# Observations on 2.5G/5.0G Transmit Linearity Tests

IEEE P802.3bz 2.5/5GBASE-T Task Force

Atlanta, GA – January 2016

**Figure 126–35—Transmitter test fixture 4 for linearity measurement of 2.5GBASE-T with sine wave injected**

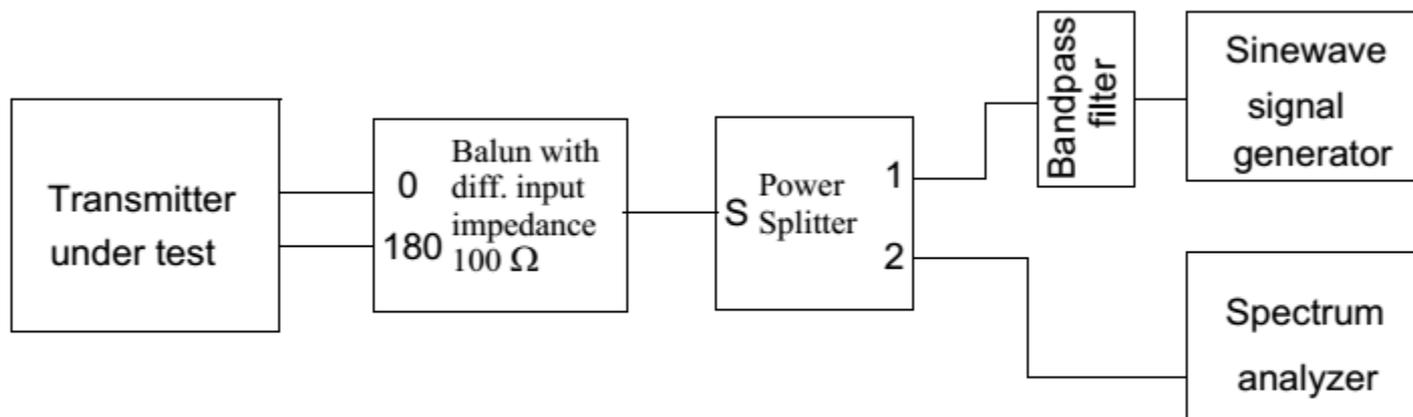
- Support for the proposed 2.5GBASE-T Transmit Linearity Test with Link-Partner Signal as Disturber
- Clarify elements of the Figure 126-3 Transmitter test fixture 4 for linearity measurement of 2.5GBASE-T with sine wave injected
  - Compare with Transmitter test fixture 3, where the filter characteristics are summarized in the figure and descriptive text.
  - Do we need requirements on the band pass filter included in the test fixture?

Figure 126–34—Transmitter test fixture 3 for transmitter jitter measurement (to update)

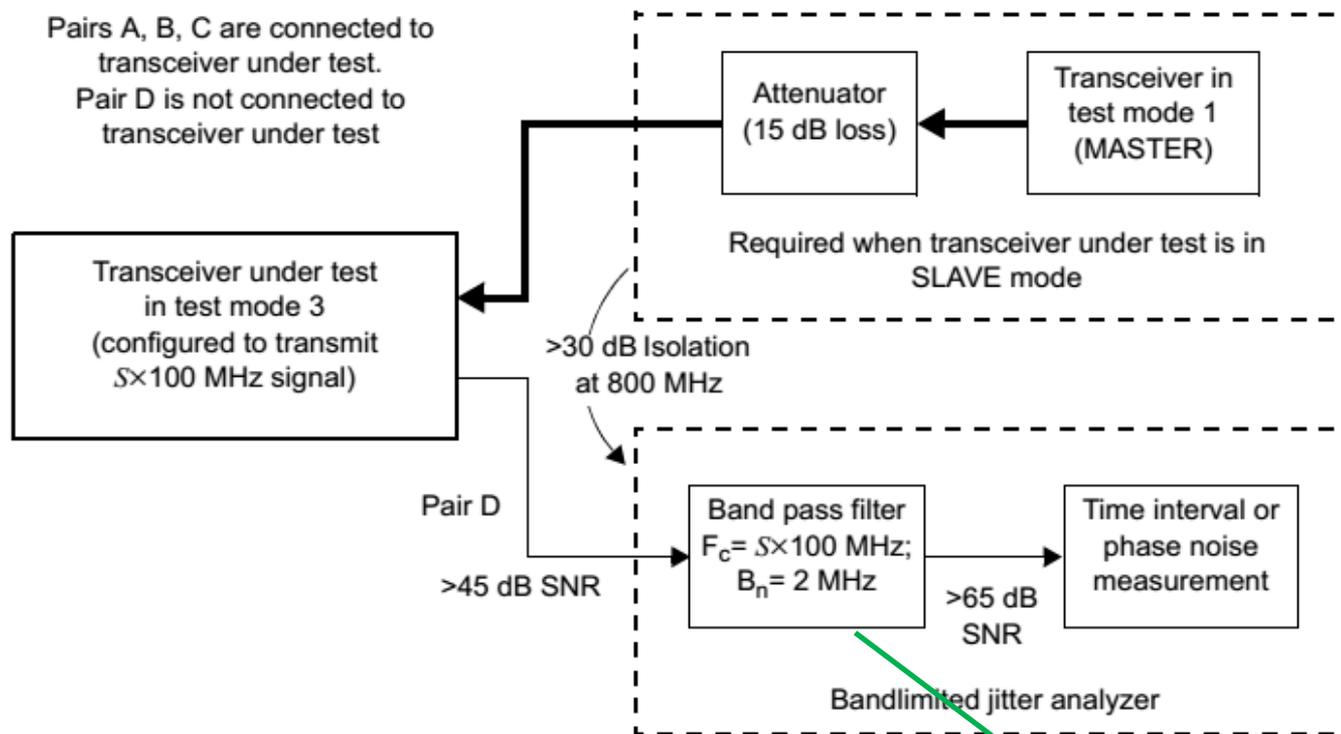
Band pass filter characteristics

Figure 126–35—Transmitter test fixture 4 for linearity measurement of 2.5GBASE-T with sine wave injected

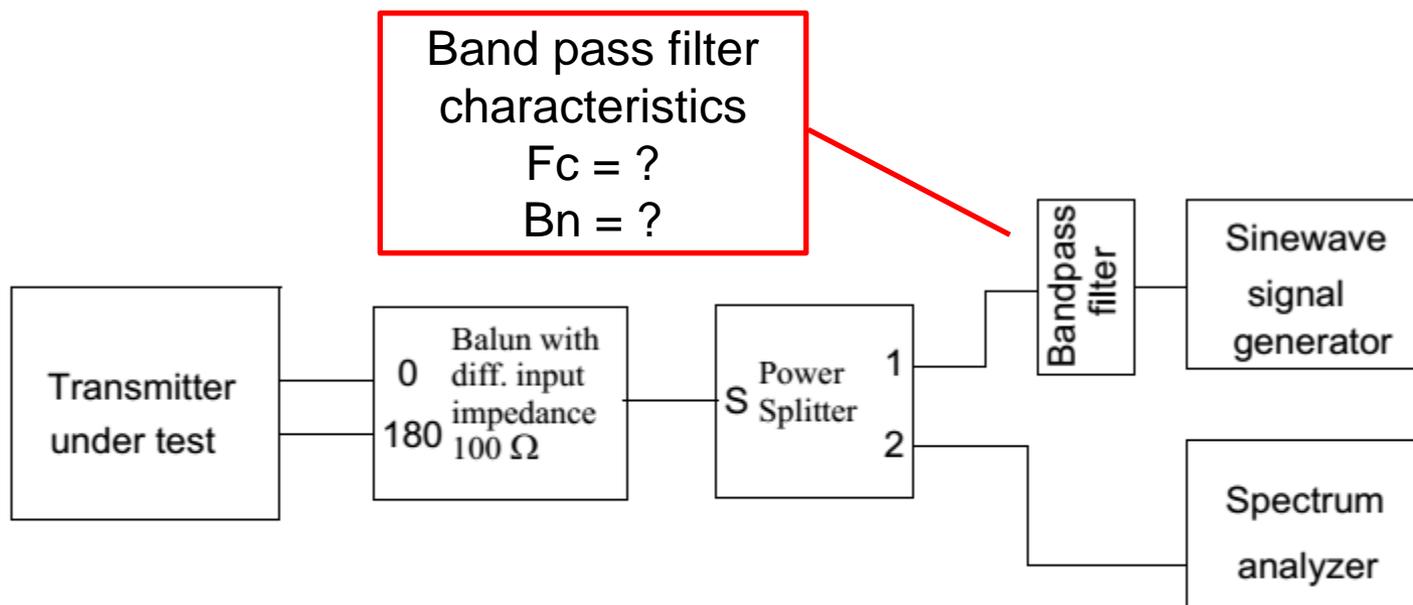
Do we need to define the band pass filter characteristics?

- Section 126.5.2.1 Test Fixtures, Page 147, Line 44
- Add the following text after Line 43
  - “The center frequency ( $F_c$ ) of the band pass filter shown in Figure 126-35 is 45 MHz  $\pm$  200 kHz and the band pass filter noise bandwidth is 2 MHz  $\pm$  200 kHz.”
- Include  $F_c$  and  $B_n$  in Figure 126-35
- Opportunistic minor editorial change
  - Change “show” in Line 42 to “shown”
